65-F-229
W.P. # 247-65
HWY # 402
MURPHY
ROAD

Re: Soil Conditions and Foundations,
Proposed Murphy Road Overpass,
Highway No. 402,
Sarnia, Ontario.

FOUNDATION INVESTIGATION REPORT BY:
Gecon, Ltd., Consulting Engineers -
Proposed Murphy Road Overpass, Hwy. 402,
Sarnia, Ontario, District #1 (Chatham).
W.P. 247-65 -- Site 14-238

Subject: W.P. #247-65, Bridge Site #14-328,
Murphy Road Underpass,
at Sarnia East Limits,
Hwy. #402, District #1.

PROPOSED CROSSING
AT
MURPHY ROAD
AND
THE KING'S HWY. 402
LOT 19 LOT 18 CON 7
CITY OF SARNIA TOWNSHIP OF SARNIA
COUNTY OF LAMBTON

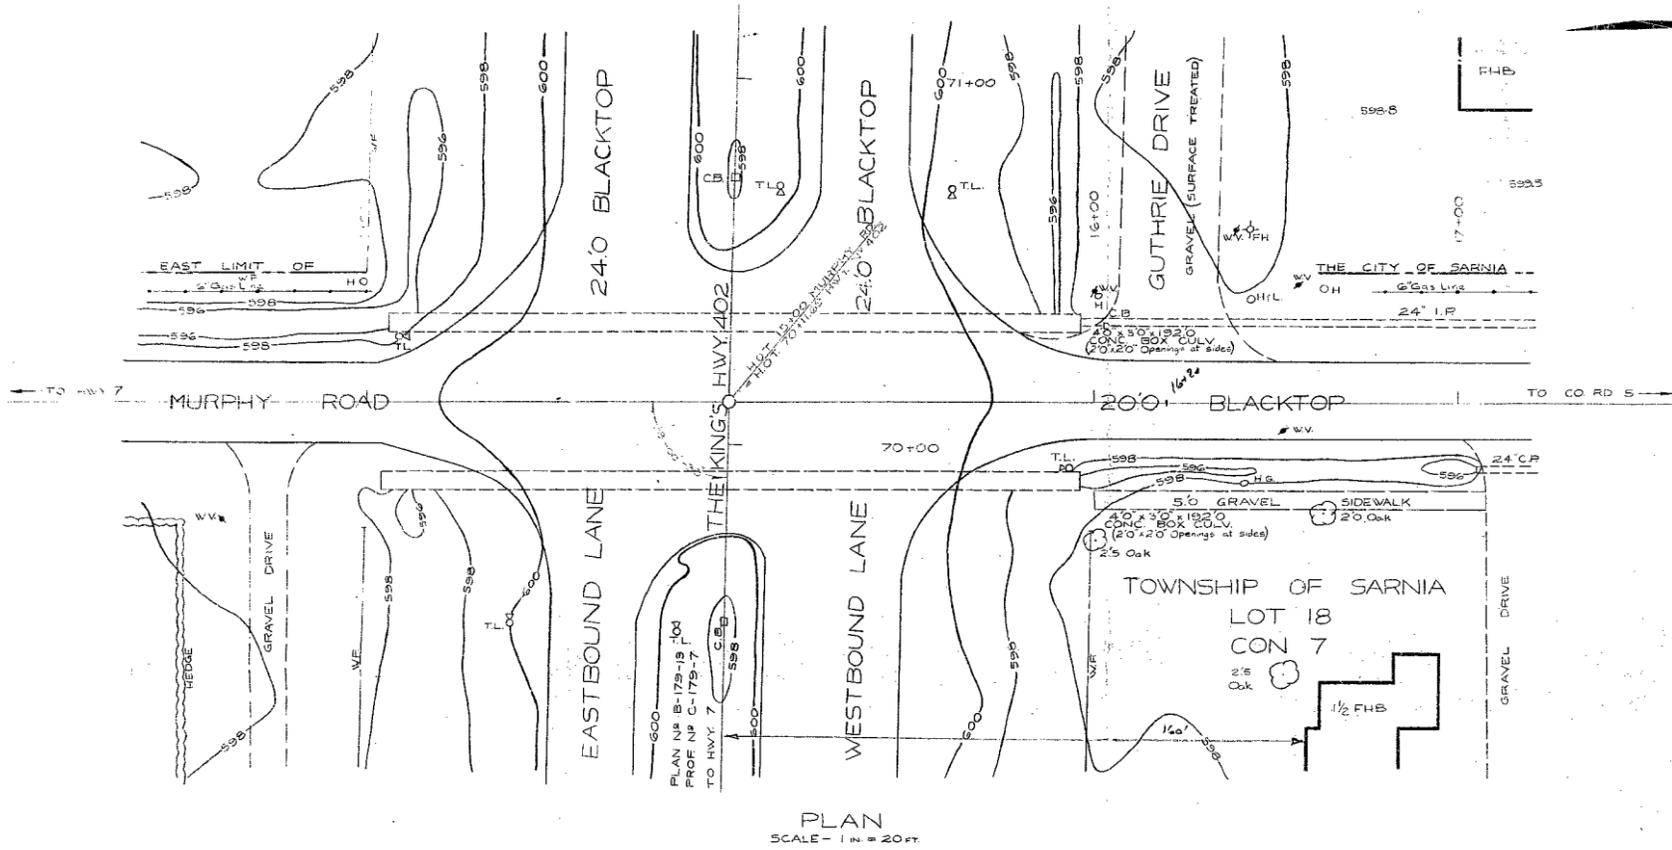
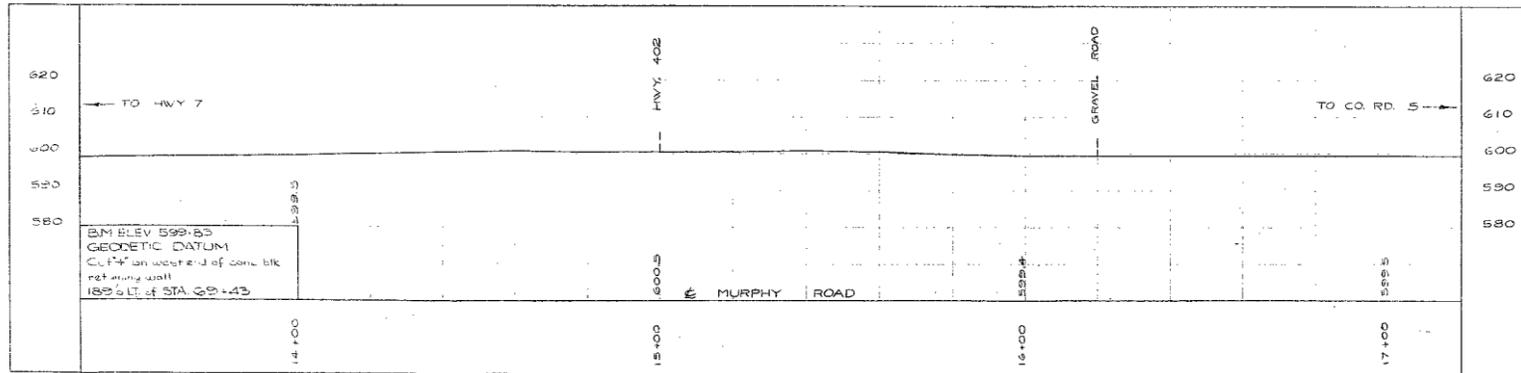
Your attention is drawn to the incorrect chainage of the Murphy Road as given in the report and the accompanying drawing. There is a 500-ft. difference - i.e., chainage 15+00 shown on the drawing should read 20+00. The error has resulted from the incorrect chainage shown on the drawing 647-B-08 which was given to the consultant prior to the commencement of the field work. It is suggested that you make the necessary corrections on the Cronaflex copy from which the prints will become part of the contract drawings. This same accompanies all copies of the report and therefore, changes in the report and on the drawing are not necessary.

To confirm the information given to me today, the
centre line of Murphy Road crosses Hwy. 402 at Station
14 + 87 as shown on Bridge Site Plan E 4346-1.
